LUA Bulimba – Other Change Application – 187–193 Oxford Street, Bulimba

1 Introduction

This report has been prepared by Urbis on behalf of Oxford Precinct Pty Ltd in support of an Other Change Application for the approved Lua Bulimba development at 187–193 Oxford Street, Bulimba. The application seeks approval for architectural and functional refinements to the approved rooftop and roof terrace areas, including revised roof terrace layout, wellness and pool facilities, mechanical plant zones, service areas, roof form and associated elevation updates. The proposed changes are shown on the architectural submission package prepared for the project, including proposed roof terrace, rooftop and elevation drawings dated 7 September 2026.

TITLE		ELEVATIONS - SHEET 02	
DRAWING NUMBER		A-1601	
REVISION		8	
SCALE (A3) 1 : 250		DATE 11/02/26

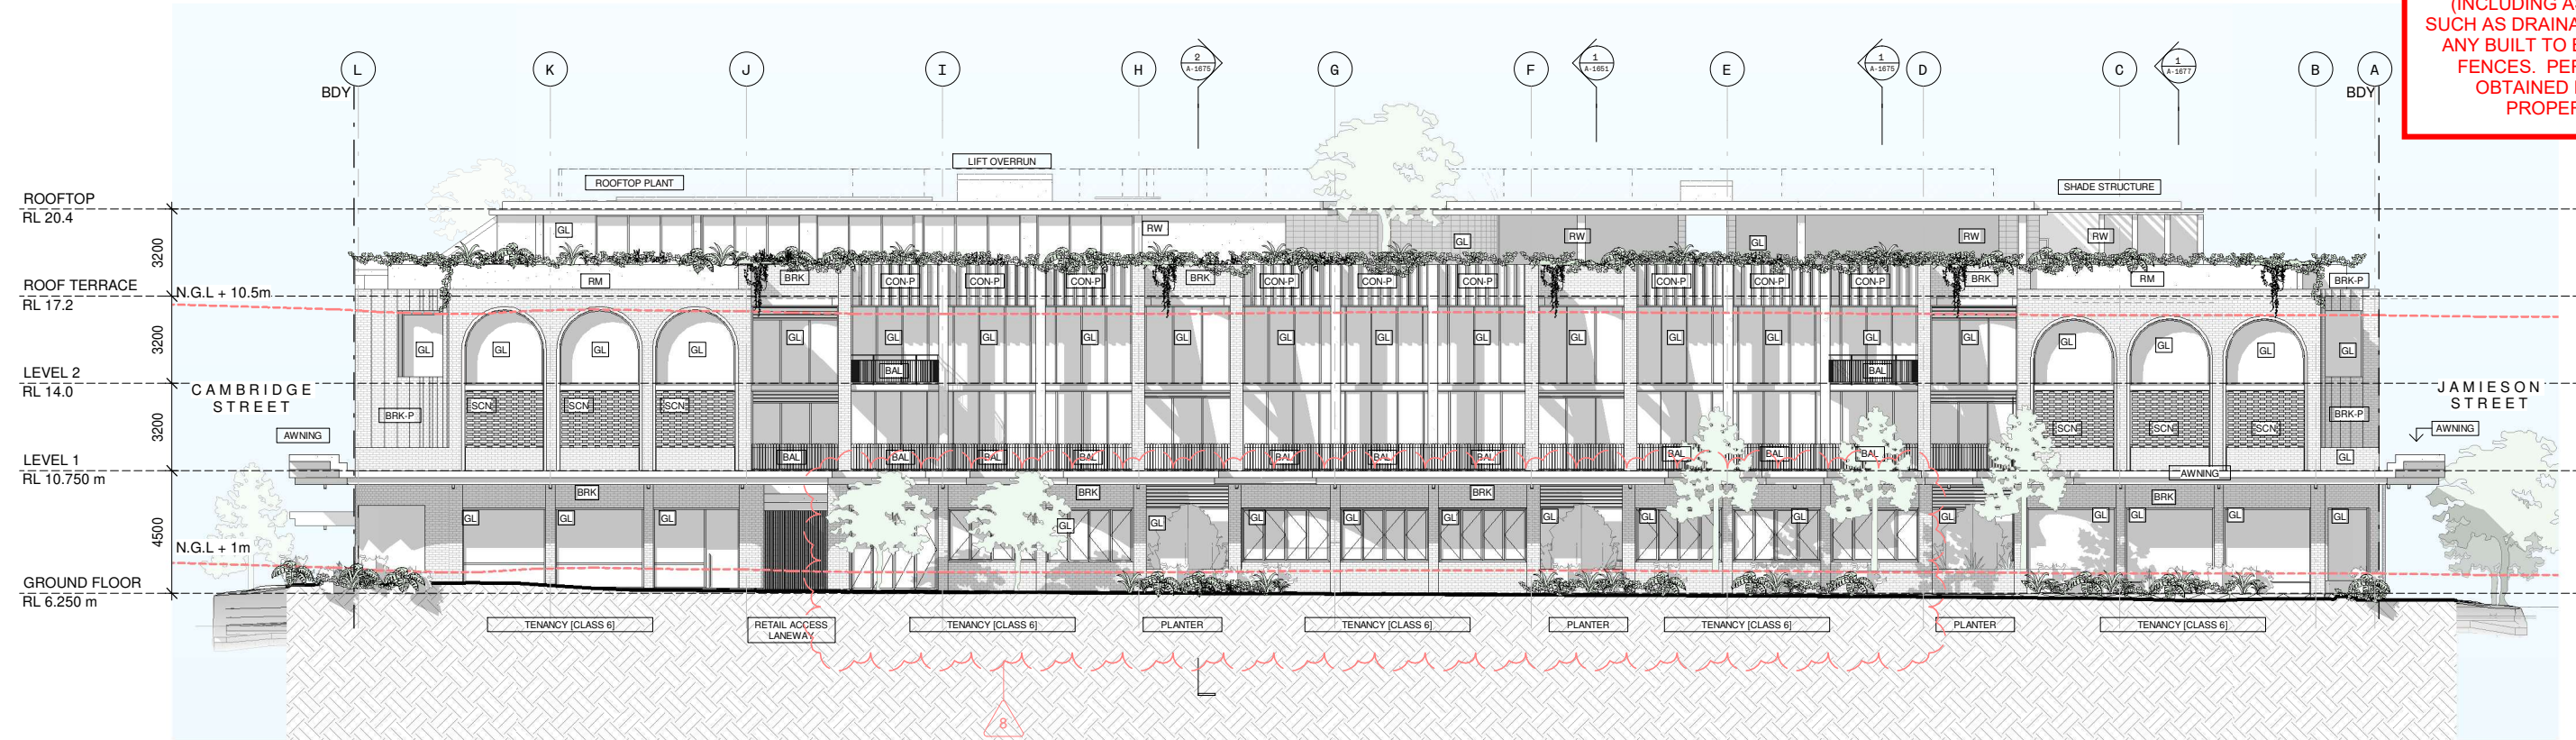
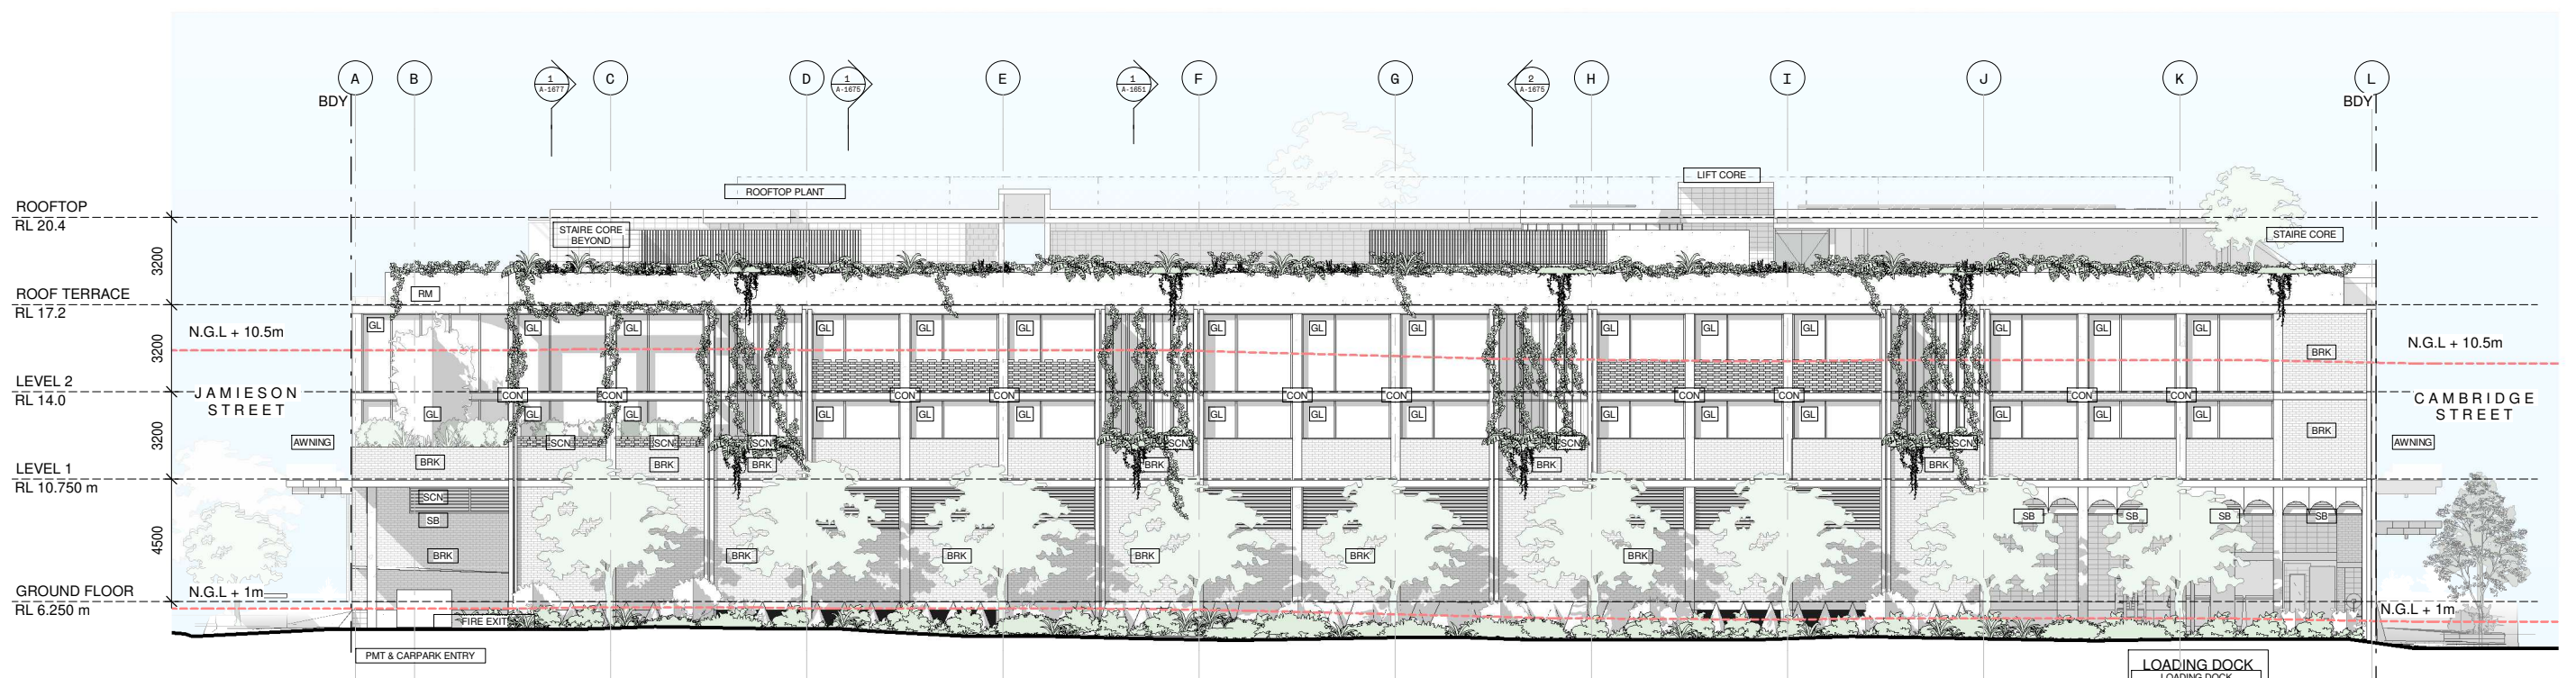
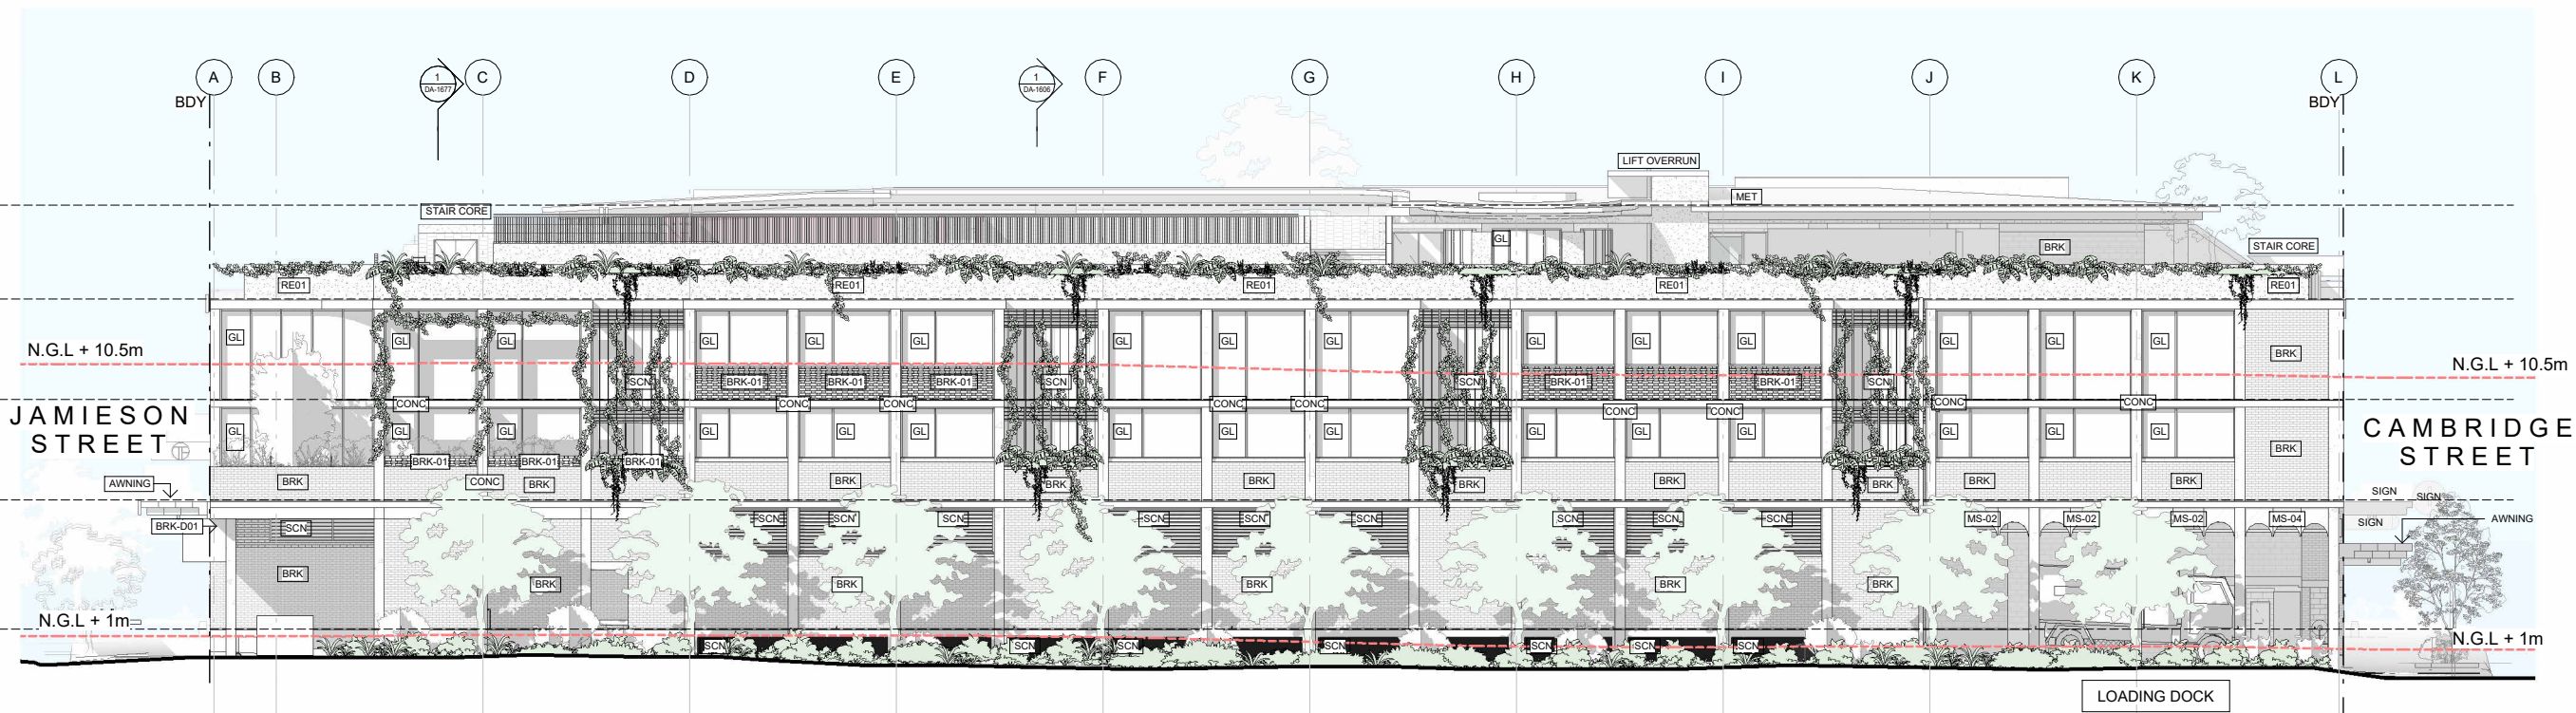
Elevations Sheet 02 A-1601, Revision 8, dated 11 February 2026. Shows the approved north and south elevations, including the approved roof terrace and rooftop levels, façade composition, awnings, glazing, screening and rooftop plant expression.	Elevations Sheet 02 DA-1601, Revision A, dated 7 September 2026. Shows updated north and south elevations with roof terrace RL 17.750 m, top of eaves RL 21.020 m, RL 22.220 notation, updated awnings, façade materials, screening, signage references and roof form.	The proposed elevations include consequential updates arising from the revised rooftop and roof terrace design. The overall building expression remains broadly consistent, but the amended eaves, roof form, materials and signage zones should be captured in external details and approved plan conditions.
Elevations Sheet 01 A-1600, Revision 7, dated 15 December 2025. Shows the approved east and west elevations,	Elevations Sheet 01 DA-1600, Revision A, dated 7 September 2026. Shows updated east and west elevations with revised	The proposed elevations clarify the revised roof profile, lift overrun, stair core, façade treatments, signage and edge conditions. The changes remain consistent with the approved built form intent but require

Original approved plan	Proposed updated plan	Key changes
including Oxford Street interface, neighbouring building relationship, rooftop plant, lift overrun, stair core and material legend.	roof ridge RL 21.638, RL 22.220 notation, top of eaves RL 21.020 m, signage zones, awnings, façade materials, screening and building edge treatments.	updated drawing references and confirmation of applicable height controls.

Condition	Recommended amendment	Justification
Condition 13 – overall height	Update the listed levels to align with the revised plans, including roof terrace RL 17.750 m, top of eaves RL 21.020 m, ridge RL 21.638 m and lift overrun / maximum roof element RL 22.220m.	The proposed elevation and rooftop drawings show amended roof terrace, eaves, ridge and rooftop level references. The condition should match the approved built form to achieve certification as required by the condition.
